# Zoning Staff Report

**Case Number:** ZC-25-026

## Zoning Map Amendment & Site Plan

Livano Elizabeth Creek  
Development Plan  
TRACT 2A of the DANIELS SURVEY  
362 ABRSTRACT NUMBER

DP

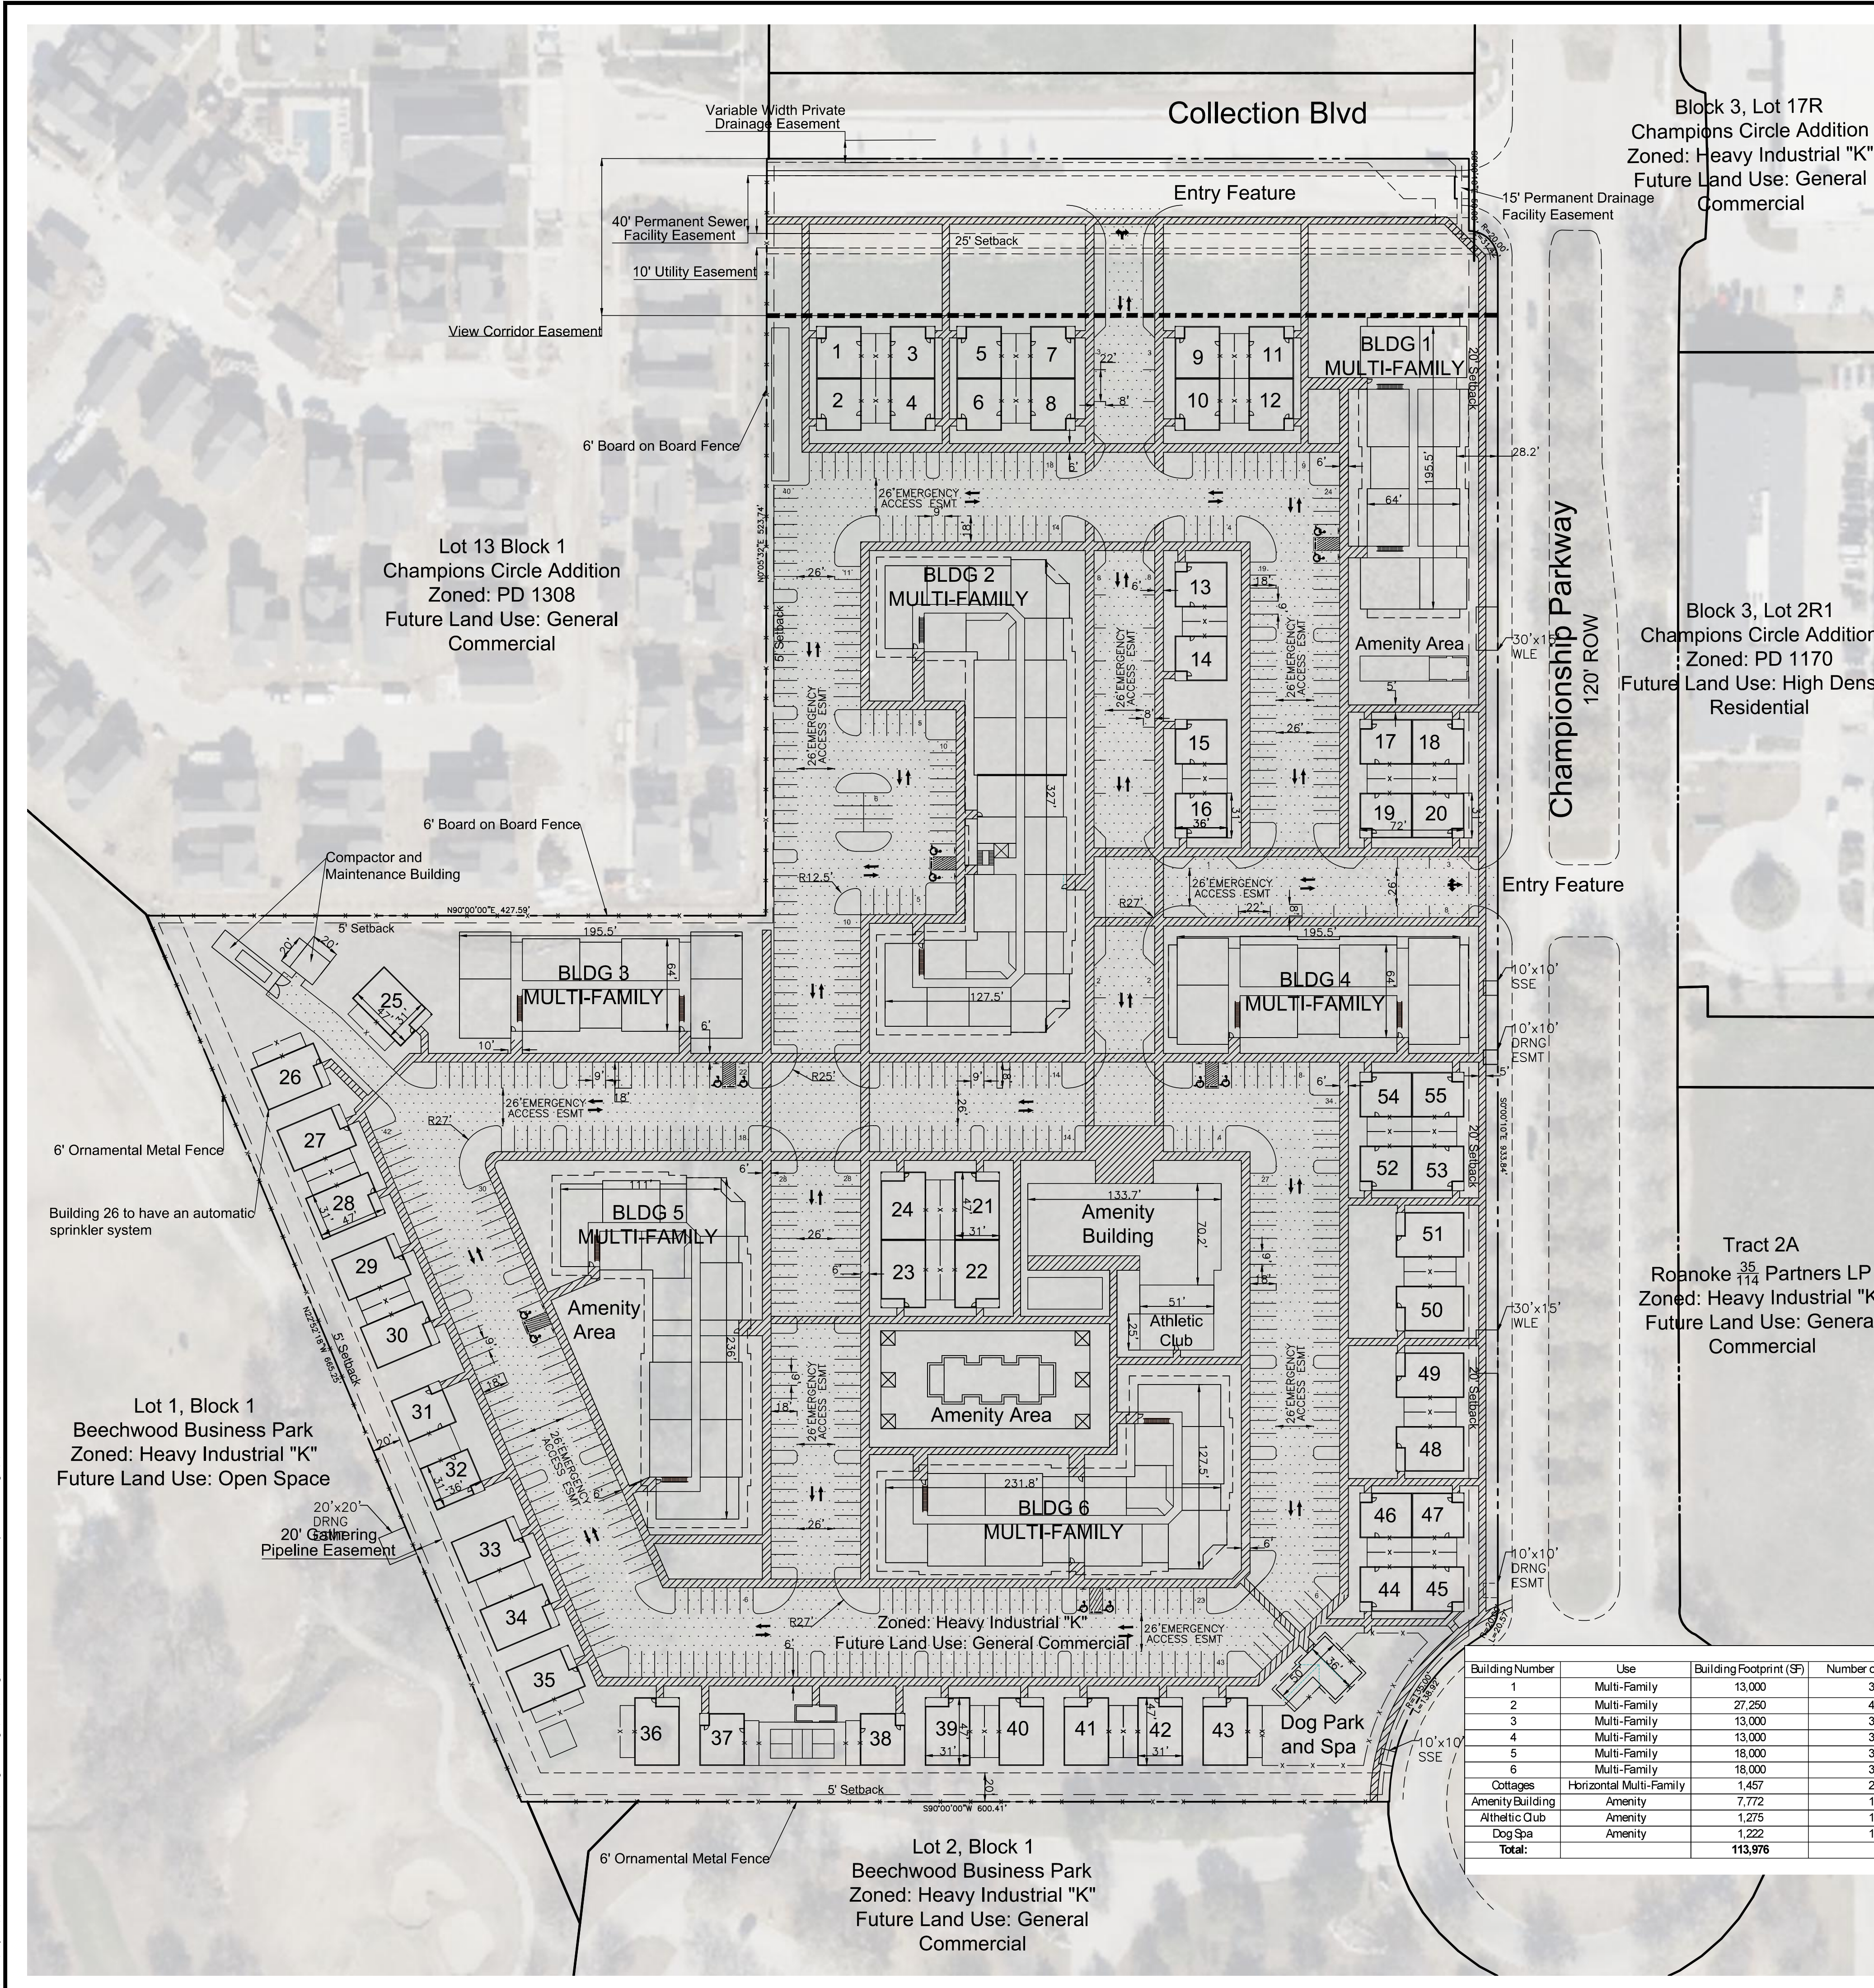
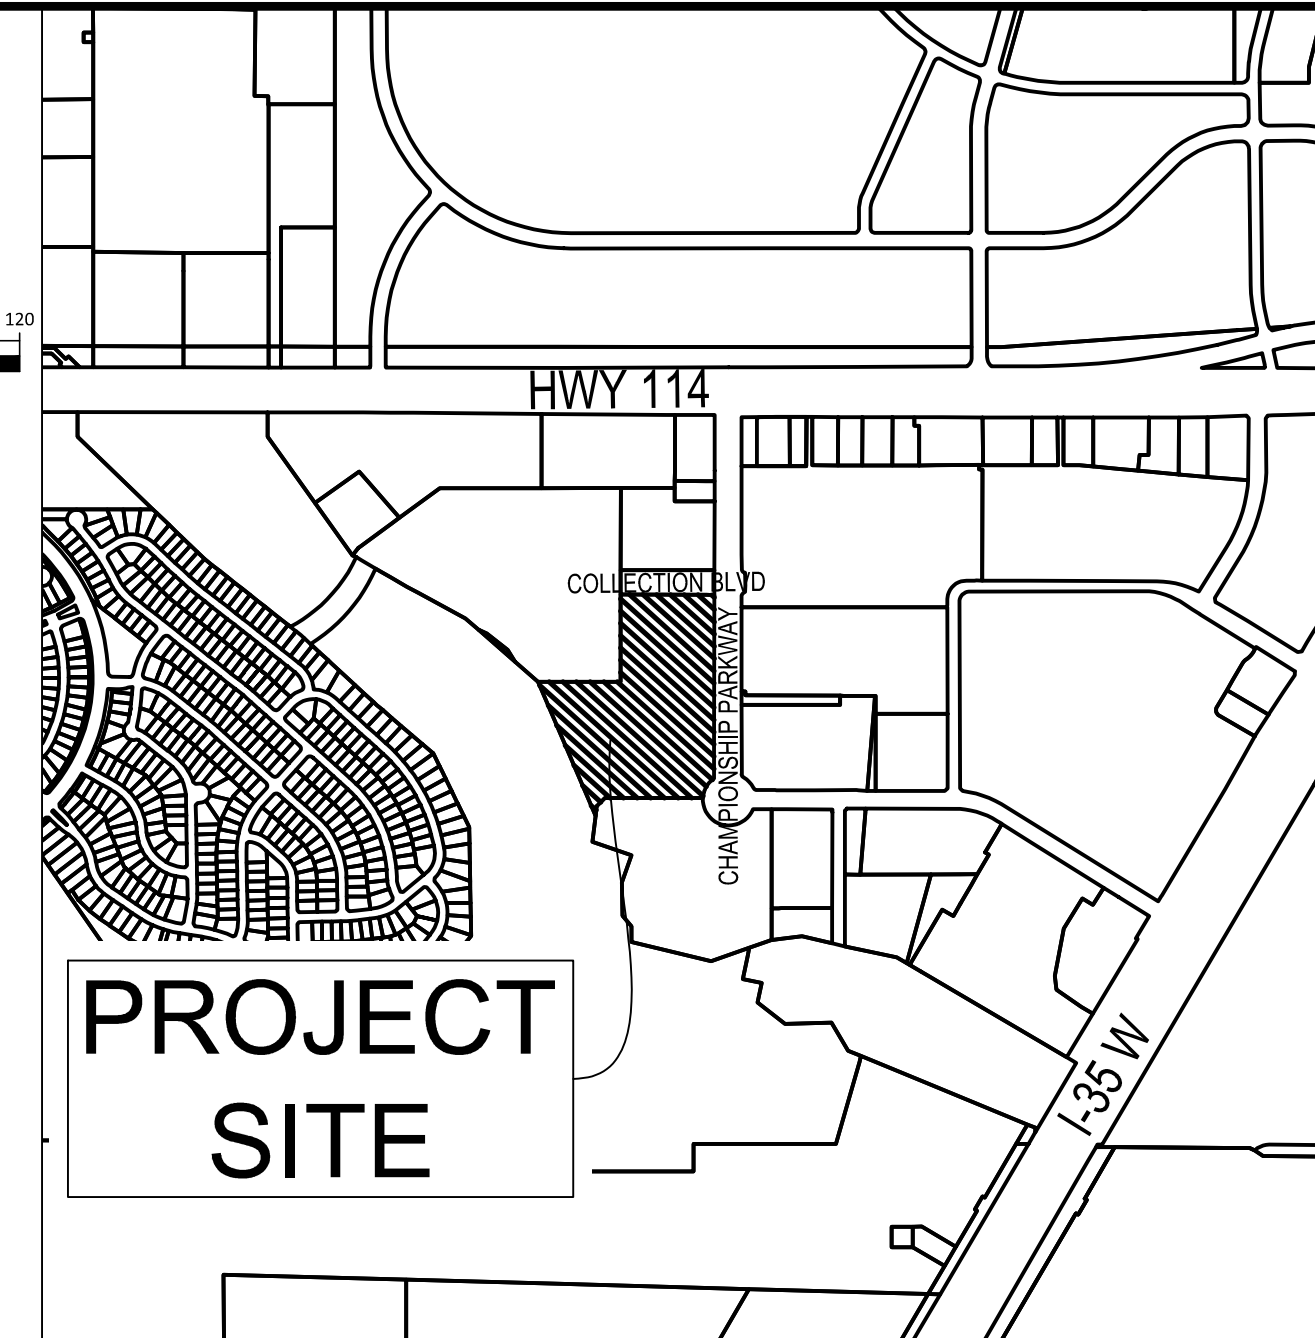
\* Provide the case number and a signature line in the lower right hand corner.

\* For the multifamily the parking will be reviewed at one space per bedroom plus 250 sq. ft. common area. (Waiver required for less)

\* For the detached multifamily the parking will be reviewed at 1 space per bedroom. (Waiver may be required)

\* Required Open Space is 45%. (Waiver required for less)

\* Maximum height is 36 ft. slab to top plate for multifamily. Waiver required for additional height)

\* Provide the total number of units.

\* Add the following language to the site plan:

~~Variation of roof elevation and exterior wall materials and colors shall be incorporated to provide architectural variety allowable materials to include: brick, stone, synthetic stone, stucco and fiber cement siding.~~

Interior fire lanes are marked correctly at 26' wide.

Minimum turn radii: 25' inside and 51' outside.

Fire lanes and Emergency Access Easements must provide hose lay for each building within 300' for buildings equipped with a fire sprinkler system.

Additional hydrants will be required to accommodate the following:  
Maximum of 600 ft. (300 ft. radius) spacing between hydrants along a direct horizontal line, and  
Maximum of 500 ft. hose lay distance to all points of building.  
Maximum distance from Fire Department Connection (FDC); if sprinkler systems or standpipes provided:  
Maximum of 150 ft. for a standpipe system, and/or a sprinkler system.  
IFC 2021/CFW Adopted Amendments Ordinance #25388-03-2022 Sections 507.5.1 (2) and (3)

Vehicle gates are required to be a minimum of 20' wide when fully opened and equipped with Knox Locks. Permits are required for electric gates.  
Section 503.6 Security Gates

General Note Item 7 for NFPA13D automatic fire sprinkler system is NOT required.  
General Note Item 8.3-Adequate parking is imperative for emergency response. Fire Code does not have a standard for parking capacity but it is important to note that inadequate parking has historically led to parking within fire lanes.
